MITSUBISHI SERVICE PUBLICATIONS TRANSMITTAL

**MU-2**

SUBJECT: Goodrich Service Bulletin – Propeller De-Icer Timer Repair (SB 3E1150-30-01)

PROPELLER DE-ICER TIMER REPAIR – GOODRICH P/N 3E1150-10 AND 3E1150-12

Figure 1: Propeller De-icer Timer Assembly

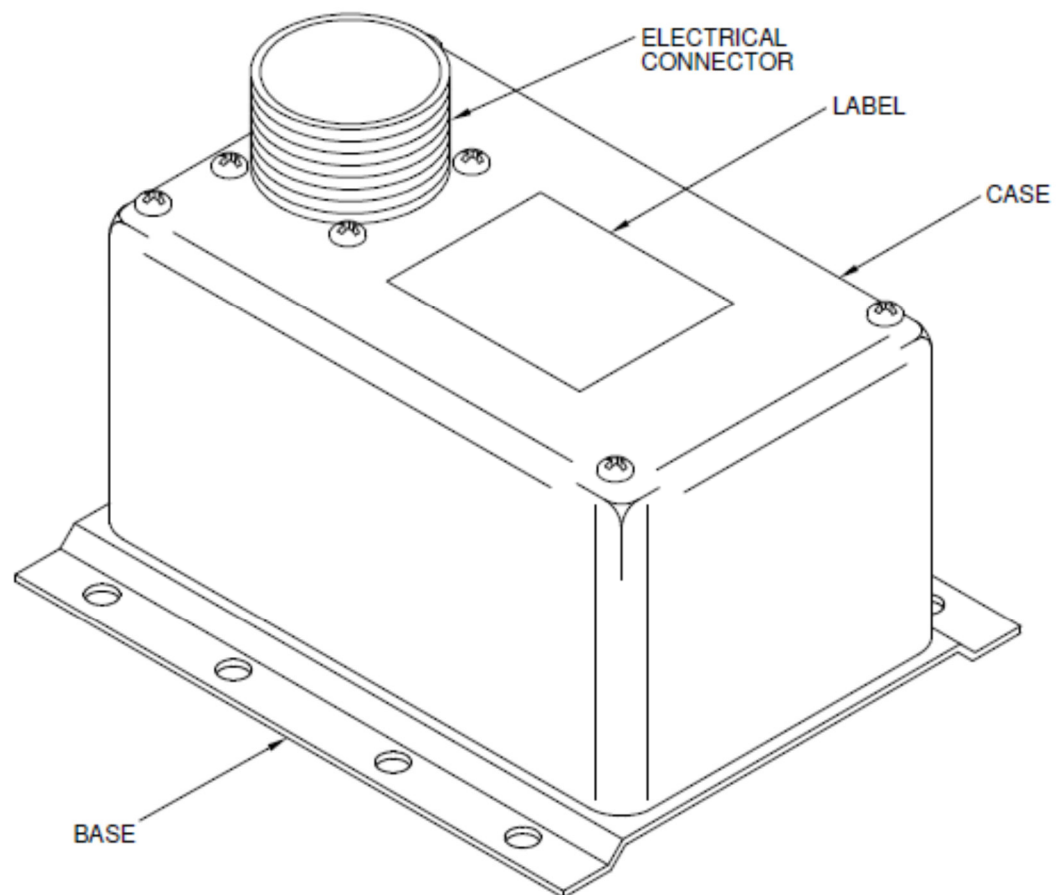
Some propeller de-icer timers may have experienced, or may be susceptible to experiencing failures due to a foam cushion, which may degrade over time in service. This Service Bulletin identifies actions necessary to:

- replace the foam cushion with a new cushion that will not degrade
- repair any damage that may have occurred due to the degradation
- apply protective coating to the printed circuit board to minimize the possibility of future malfunction.

This service bulletin introduces a repair that has been developed to replace degrading foam cushions and to clean and seal the circuit board that may have been affected by the degraded foam.

The repair consists of disassembly of the timer, and removal of the foam cushion. The printed circuit board assembly is cleaned of any residual foam, foam adhesives and any contamination due to the degraded foam. The cleaned printed circuit board is then conformal coated and a new foam cushion is installed. The timer is reassembled and a functional test is performed per the Returned Goods (RG) repair spec.

With reference to assembly drawing 4E2278, remove and discard foam cushion (item no 3). Clean the circuit board of foam residue or other contaminants.

Install new foam cushion, item no. 3, P/N 3K1451, per drawing 4E2278.

NOTE: Ensure that the new foam cushion is not trimmed when installed. The foam cushion is intentionally larger than the printed circuit and extends beyond the printed circuit board edge.
